SCHOOL DISTRICT 61
VIC HIGH SCHOOL

NO.	DATE	DESCRIPTION
1	AUGUST 11, 2020	ISSUED FOR VARIANCE PERMIT
2	NOV. 20, 2020	ISSUED FOR VARIANCE PERMIT REVISIONS
3	MAY 11, 2021	ISSUED FOR VARIANCE PERMIT REVISIONS

Sheet Name
Variance Submission - Site Plan - New

Variance Submission - Site Plan - New

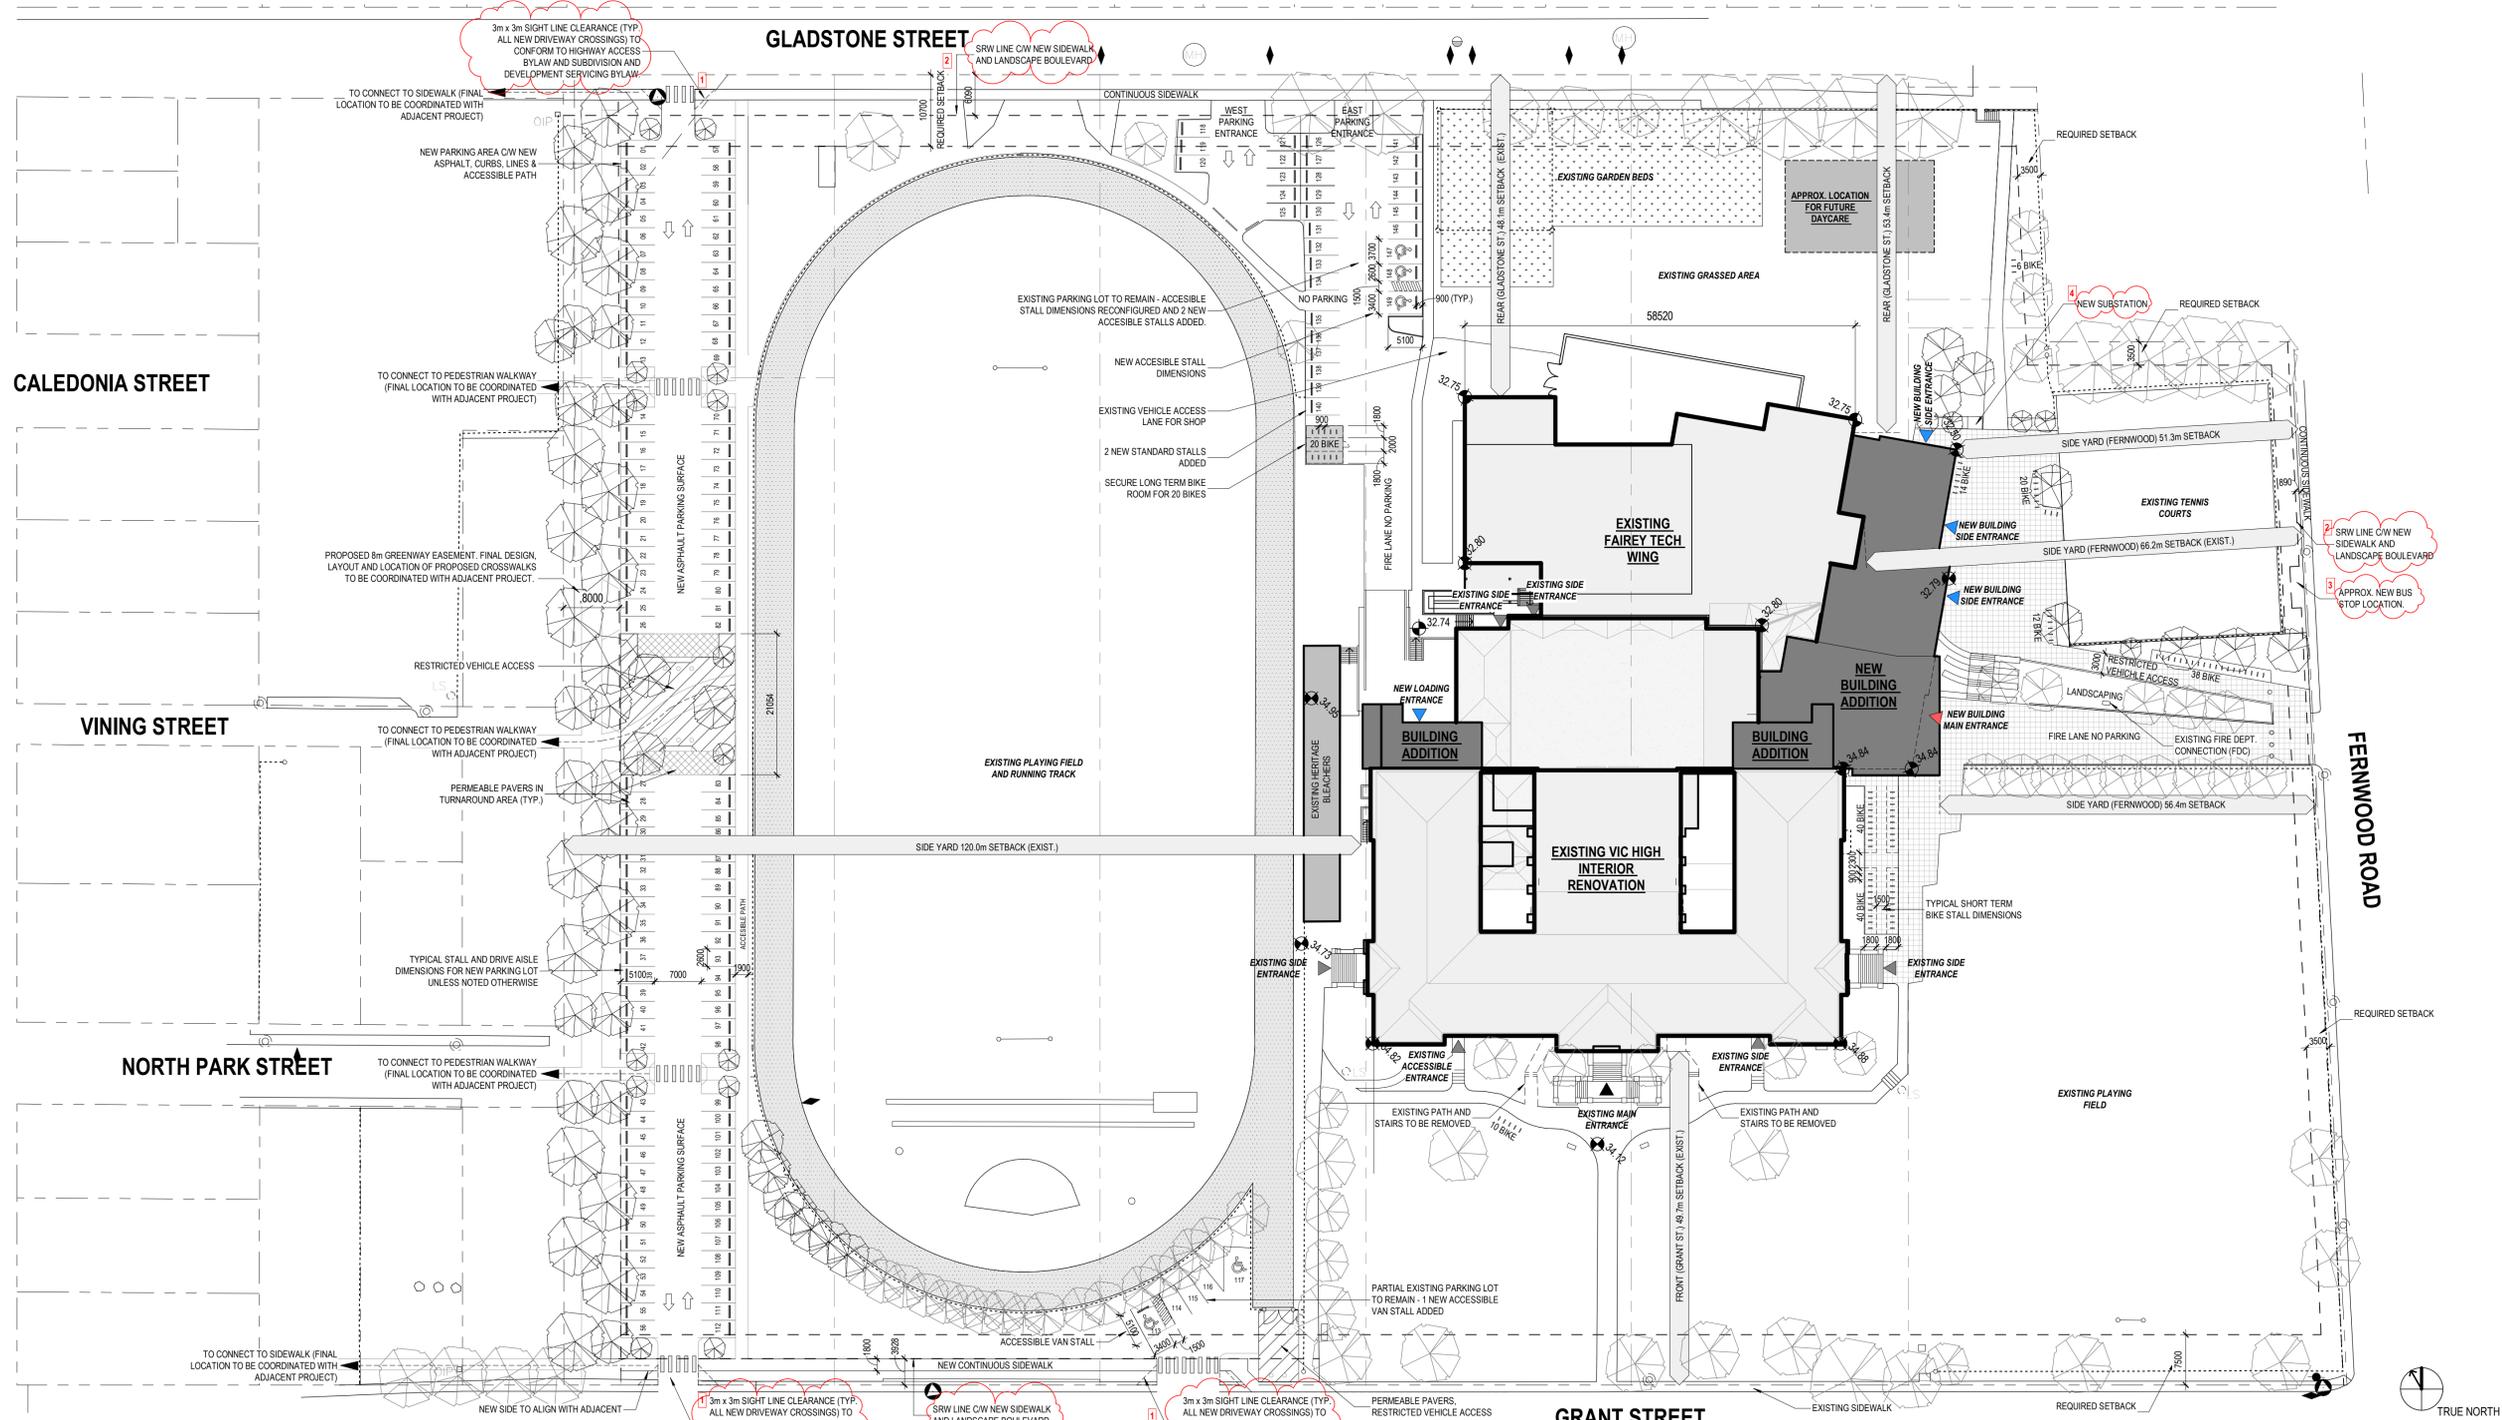
1. Sight triangles note revised to ensure conformance to Highway Access Bylaw and Subdivision and Development Servicing Bylaw.
2. SRW added to drawings. Site services work to be developed with City of Victoria Staff.
3. Approximate location of new bus stop. Final location to be developed with City of Victoria Staff and BC Transit.
4. Pad Mounted Transformer revised to new substation reflecting discussions with BC Hydro.
